## Openreach's response to Ofcom's consultation

"Wholesale Local Access Market Review:  
Consultation on pricing proposals for Duct and Pole  
Access remedies"

20 September 2017

Figure 1

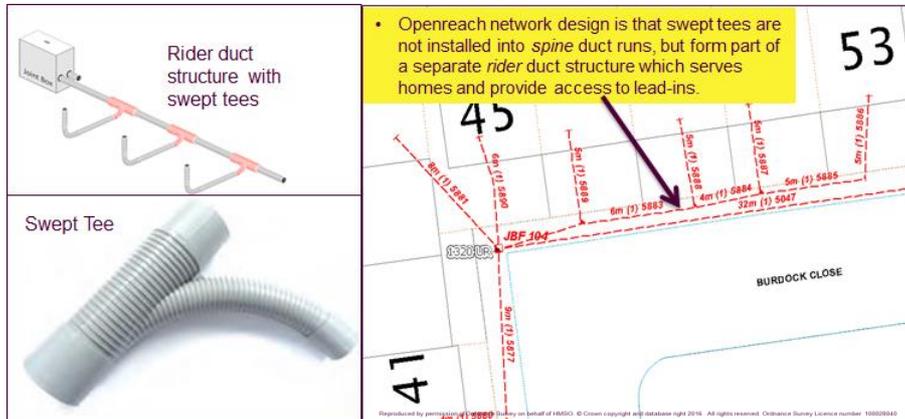
128. The Openreach network is not typically designed in the way that Ofcom portrays in Figure 4.1. Please see Figure 1 below which illustrates the standard Openreach topology. This layout is typical of that on a new housing development. Premises in older suburban areas are likely to be underground fed with overhead distribution, underground duct fed with buried lead-ins or all buried.

129. Premises which utilise swept tees to provide service are linked to a parallel ‘rider’ duct (shown by the arrow in Figure 1). The rider duct is linked to the main spine duct by a junction box. Typically these ducts would comprise circa 50mm diameter duct for the lead-in and 100mm for the rider and spine. We consider the likelihood of significant congestion in these scenarios to be very low, and hence the probability that it would result in a requirement for a new joint box also to be very low.

131. We would agree that the estimate of new boxes likely to be required is necessarily greater than zero per underground network DP, but it will be nowhere near an average of 0.5. As an illustration, if it was closer to 0.1 then that would reduce Ofcom’s limits by more than £800 per kilometre, a material correction. However as we have previously noted in this response the average actual PIA requirement may be materially less than this (i.e. of the order of [redacted] per kilometre) given recent PIA experience. Therefore we consider Ofcom’s estimate of £17 per premise passed (or circa £1,100 per kilometre) to be significantly overstated and as a result consider Ofcom’s proposals to be unjustified and disproportionate.

134. Finally, it is also our firm view that a PIA customer deciding to utilise ducted lead-ins and swept tees to serve premises would follow a similar design to us, as it is the most cost effective deployment method i.e. they would construct a rider duct with swept tees rather than the architecture illustrated in Ofcom's Figure 4.1 which shows swept tees serving premises from a spine duct.
